**PLANNING AND ZONING ADVISORY BOARD AGENDA
ADVISORY/ COMMITTEE BOARD MEETING
Village Hall Council Chambers
226 Cypress Lane
Palm Springs, FL 33461
Tuesday, November 9, 2021
6:30 PM**

ITEM 6.2: Resolution No. 2021-37 - Residential Planned Development Site Plan (SPR21-16) with three (3) waivers - Village Palm Townhomes - Vacant lot on Prairie Road (*Quasi-Judicial Hearing*)

SUBJECT: Residential Planned Development Site Plan with Waivers - Village Palm Townhomes - Vacant Lot at Prairie Road

PAVING, GRADING AND DRAINAGE PLAN

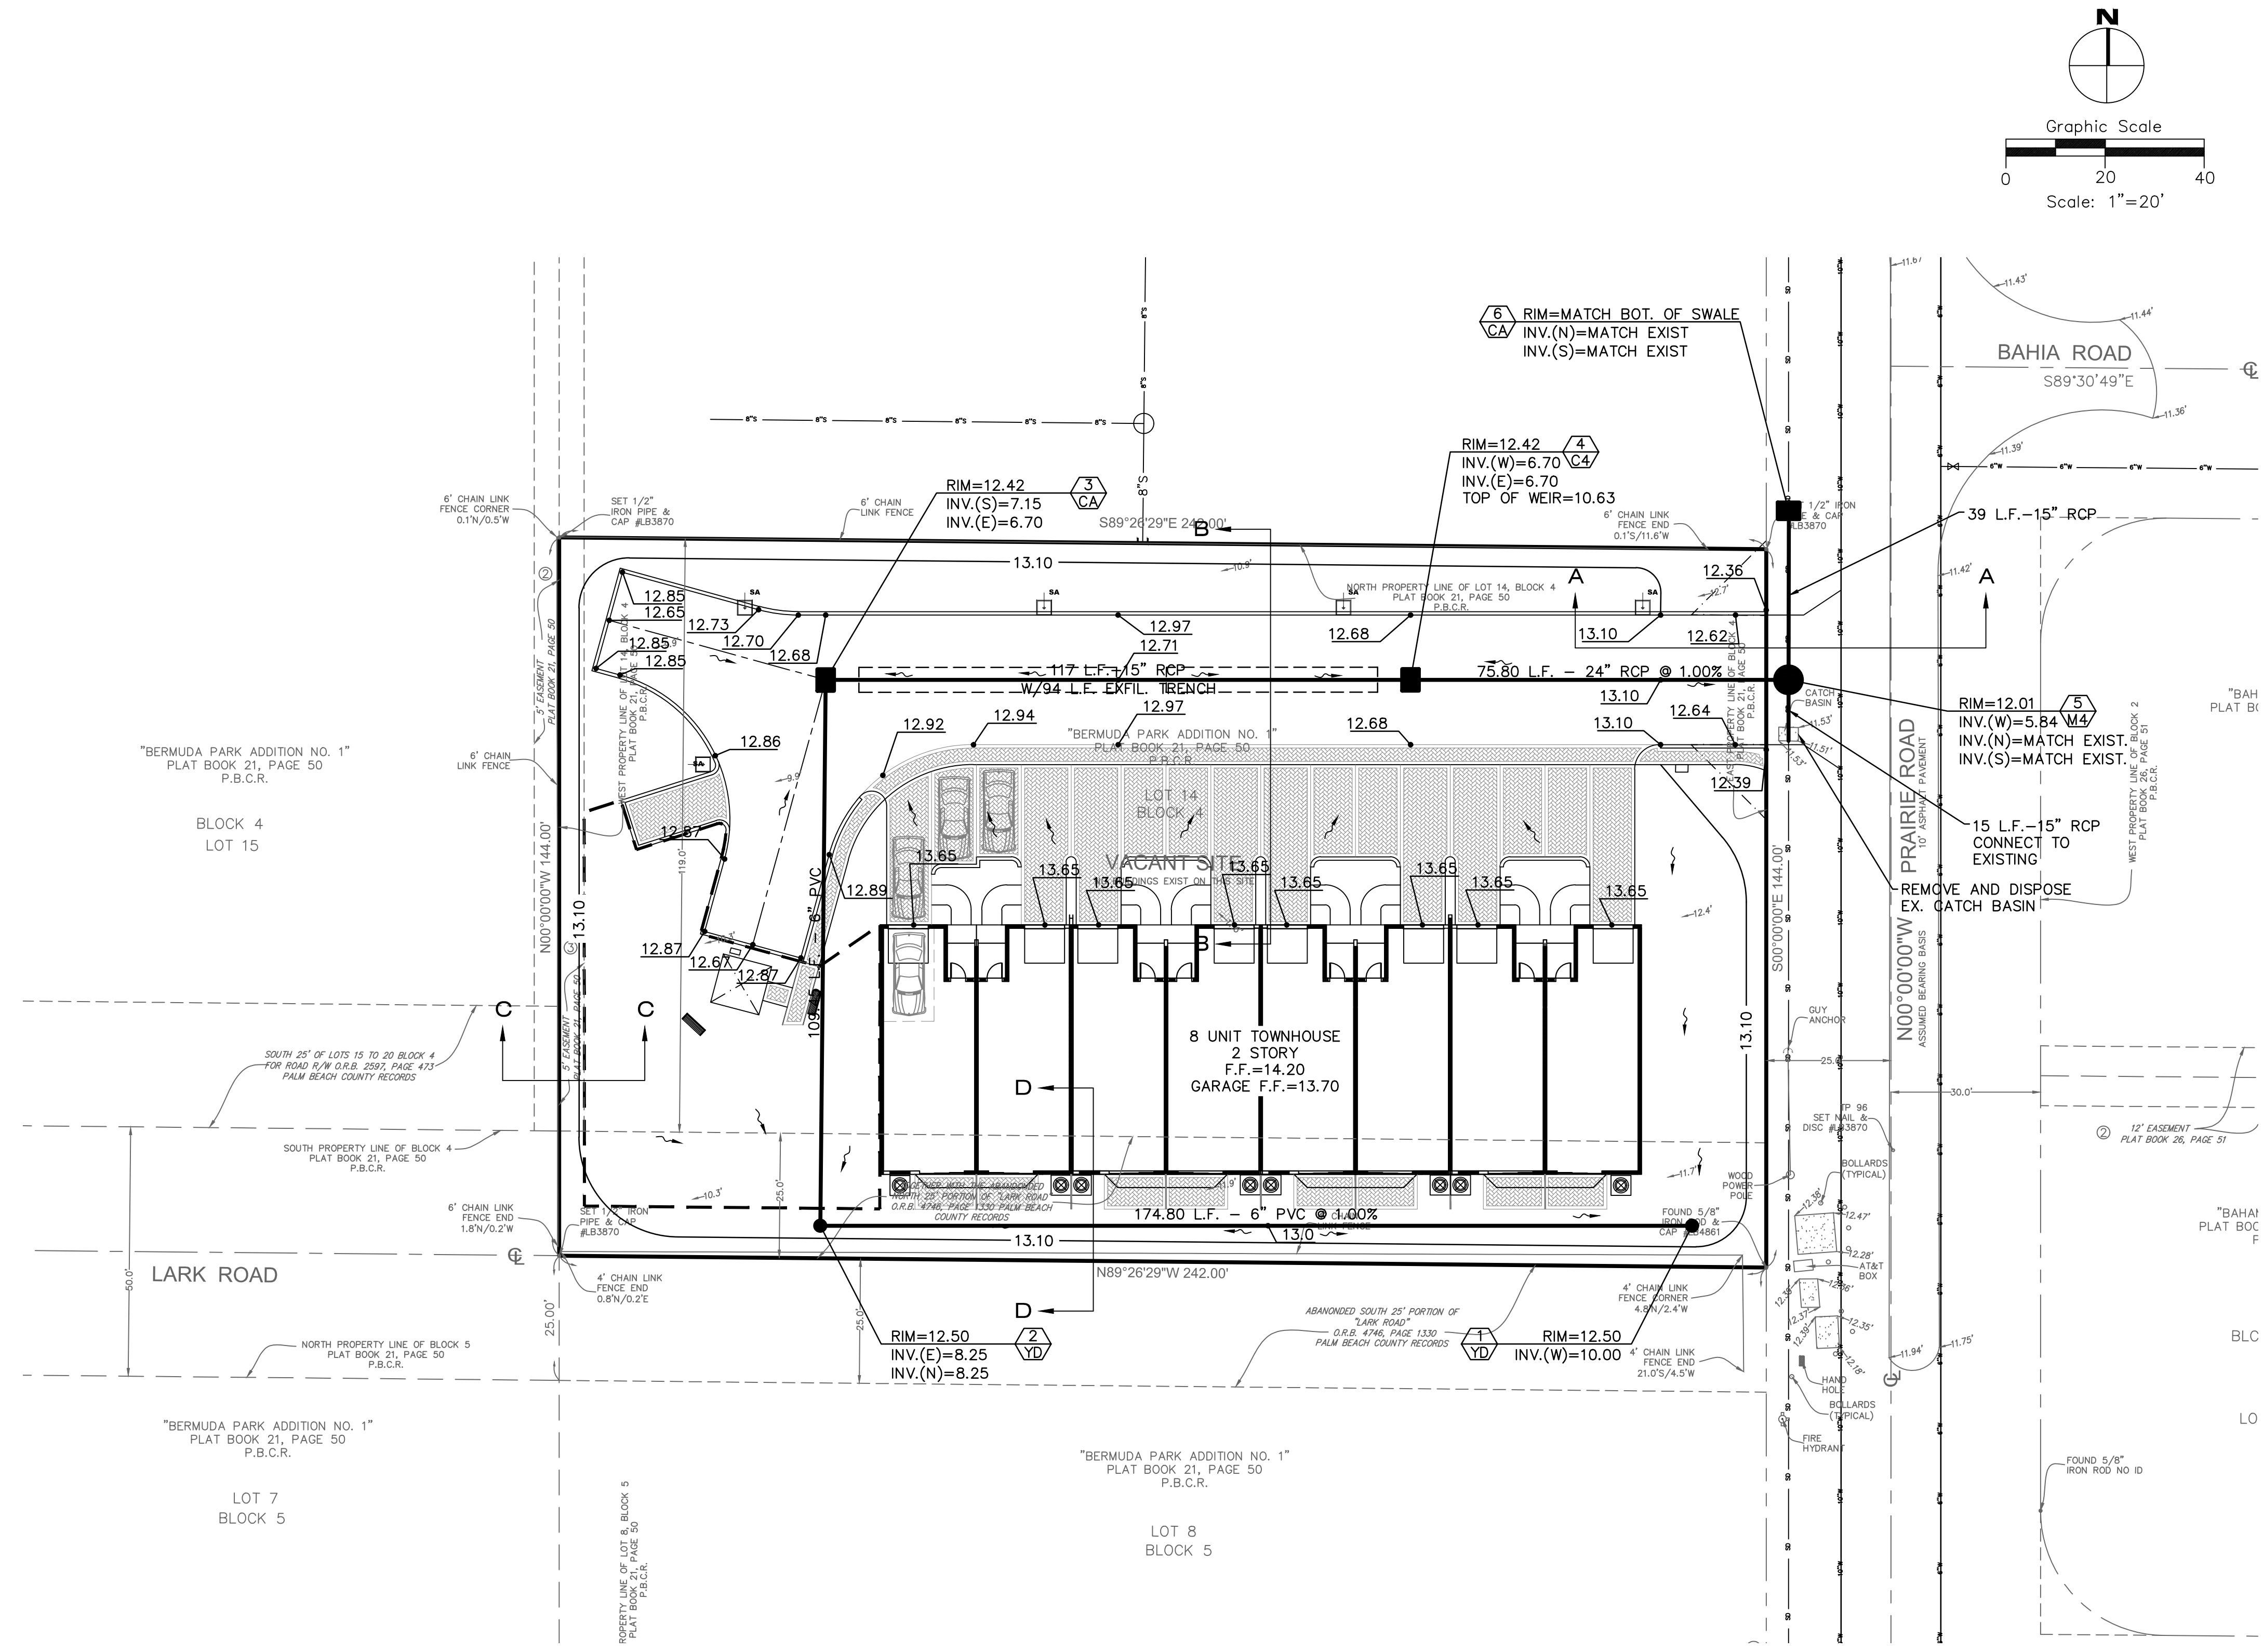
1. Per Sheet PD1,
 - a. The project driveway design in the Palm Beach County (PBC) ROW does not match the proposed PBC Prairie Road improvements. Please revise the driveway to match the Prairie Road Section. Coordinate with PBC ROW on the status of the project and improvements.
2. Per Sheet WS1,
 - a. Remove the sanitary manhole from the paver driveway.
3. Per Sheet FLP1,
 - a. Please provide evidence from the Florida Statutes that a PE can sign and seal Landscape Plan.
 - b. Landscape shall not conflict with drainage lines, drainage structures, and water system. Please coordinate with the engineering plans to resolve conflicts.

- The proposed Village Palm Townhomes project does not reflect the current design background of the Prairie Road project.
- The townhomes driveway appears to be near Station 14+60 (Sheet 6 of the Prairie Road project plans) and will impact the west swale line of Prairie Road and Structure S-108.

- S-108 was designed to accept 0.47 acres of tributary area including the roadway and a portion of the adjacent lot as shown on the Drainage Map (Sheet 5). The developer's engineer should confirm that the offsite discharge does not adversely affect the Prairie Road drainage system.
